EGG-TFBP-5213  
Revision 2

*NRC Research and/or Technical Assistance Report*  
OPERATIONAL TRANSIENT TEST SERIES

TEST OPT 1-1

DOCUMENT REVISION REQUEST

TABLE 6. FUEL ROD PEAK POWER TIME HISTORY FOR TRANSIENT NO. 1 OF TEST OPT 1-1

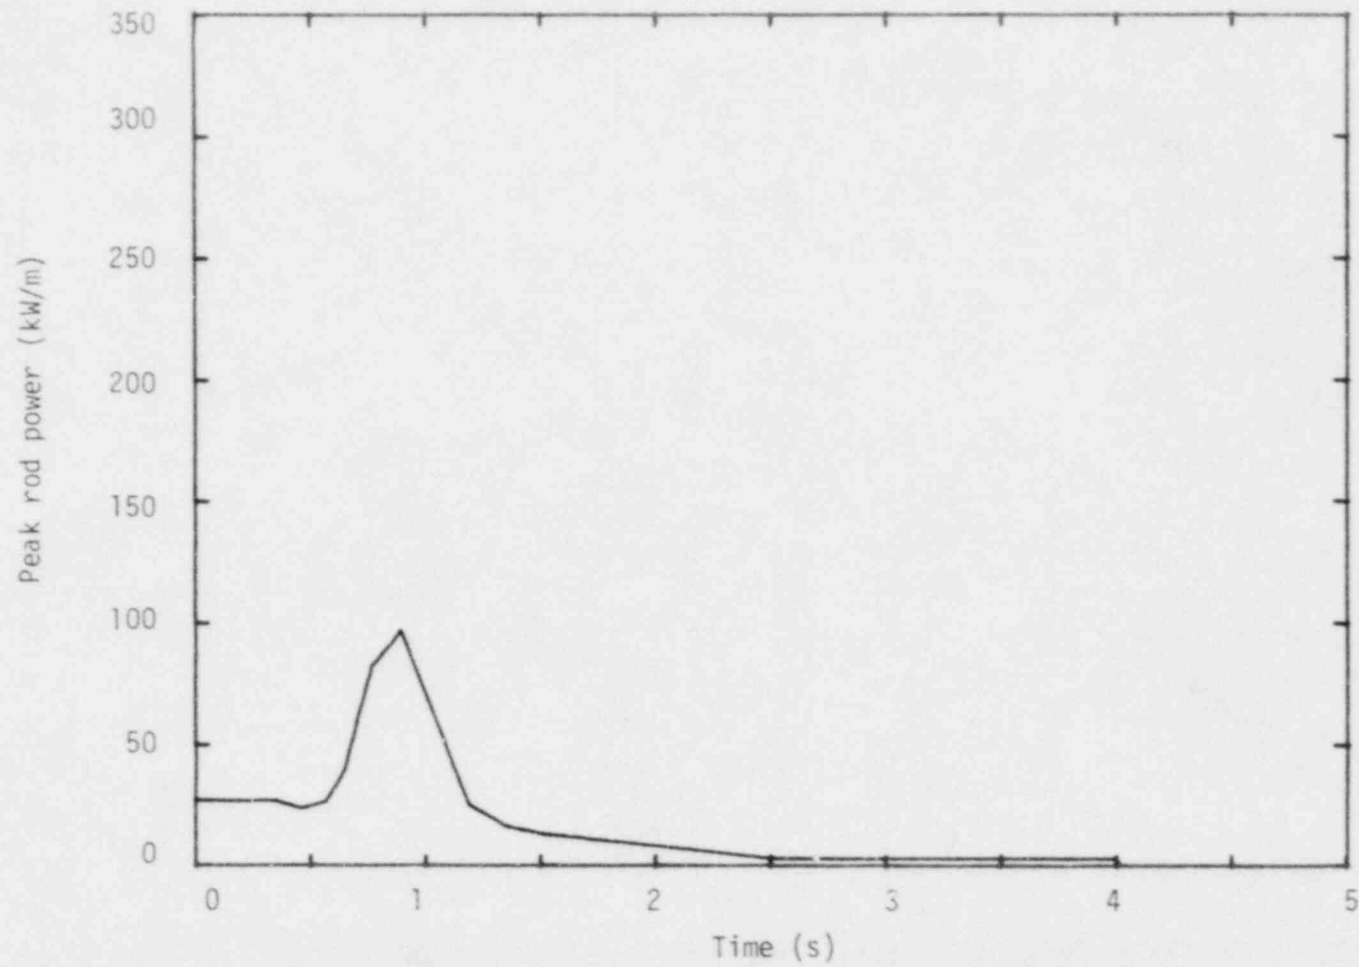
ITEM	PAGE	STEP OR PARA.	INSTRUCTIONS: REWRITE PARAGRAPH(S) OR FOR EXTENSIVE CHANGES ATTACH REVISED COPY AND STATE "REVISE PER ATTACHED COPY" FOR NEW DOCUMENT, ATTACH ROUGH DRAFT AND STATE "PREPARE NEW (SP, DOP, ETC.) PER ATTACHED DRAFT".
1	20	3.5 Line 15	Change sentence to the following: The transient rods shall be inserted into the core (34 + 1 inch) prior to the first transient at such times as requested by the OPT 1-1 Project Engineer.
2	22	Table 6	Replace Table 6 with the revised Table 6.

⑩ JUSTIFICATION: (REASON FOR CHANGE — NUMBER TO CORRESPOND TO ITEM NO. ABOVE): 1. An additional core thermal power measurement will be performed prior to the first power transient. The transient rods may be either at 52 or 34 inches during the power calibration. 2. Figure of merit is ~22% lower than predicted by reactor physics calculations. First power transient will be performed at highest core power (-20% FOM curve) analyzed for ESA.	⑪ OTHER DOCUMENTATION AFFECTED:

TABLE 6. FUEL ROD PEAK POWER TIME HISTORY FOR TRANSIENT NO. 1 OF TEST OPT 1-1

Time (s)	Fuel Rod Peak Power (kW/m)	Nominal Reactor Power (MW)
0	25	24.8
0.35	25	24.8
0.45	22	22.1
0.57	25	24.8
0.65	37	36.8
0.77	76	76.3
0.89	89	89.2
1.19	23	23.0
1.35	15	14.7
1.50	12	11.9
2.50	3	2.8
4.00	3	2.8
4.01	0	0
